**MONTGOMERY COUNTY HISTORIC PRESERVATION COMMISSION**  
**STAFF REPORT**

<b>Address:</b>	30 Hesketh Street, Chevy Chase	<b>Meeting Date:</b>	4/12/2023
<b>Resource:</b>	Contributing Resource <b>Chevy Chase Village Historic District</b>	<b>Report Date:</b>	3/15/2023
<b>Applicant:</b>	Jonathan Hacker & Kristen Donogue (Henry Chuang – Agent)	<b>Public Notice:</b>	3/8/2023
<b>Review:</b>	HAWP	<b>Tax Credit:</b>	Yes
		<b>Staff:</b>	John Liebertz

**Permit Number:** 936072 REVISION

**PROPOSAL:** Amendment to a previously approved HAWP for fenestration and other alterations.

**3 Typ. Window - Int.**  
1" = 1'-0"

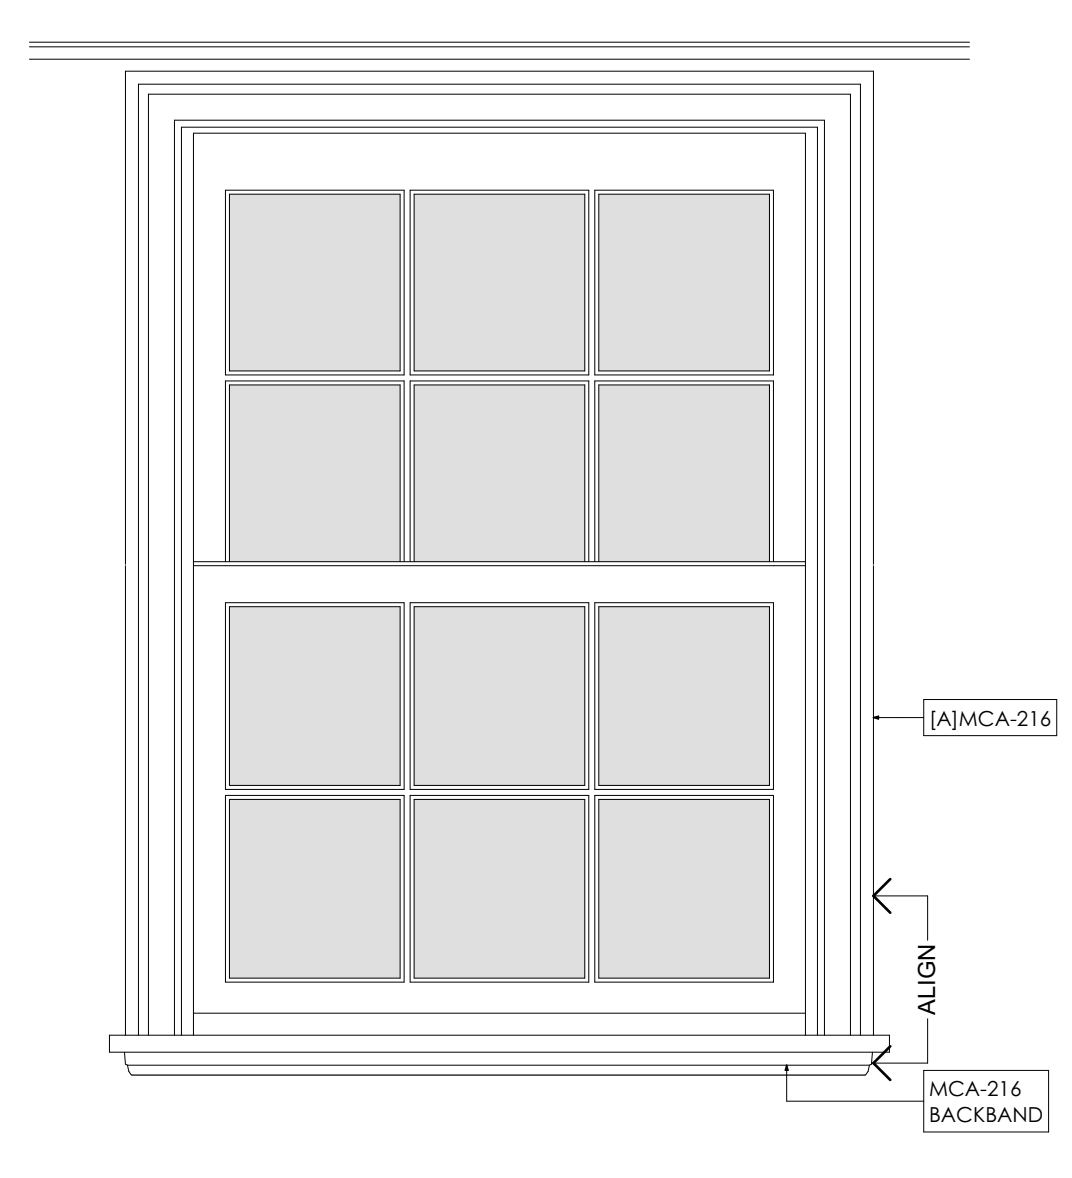
1. We would like to replace the shutters on the house. Please see sheet 0004 for details.
2. These shutters will be operable and sized to cover the entire window opening. Folding shutters will be used where required.
3. We would like to replace the existing driveway with cobbles. The footprint will remain unchanged. Material specification will be provided.
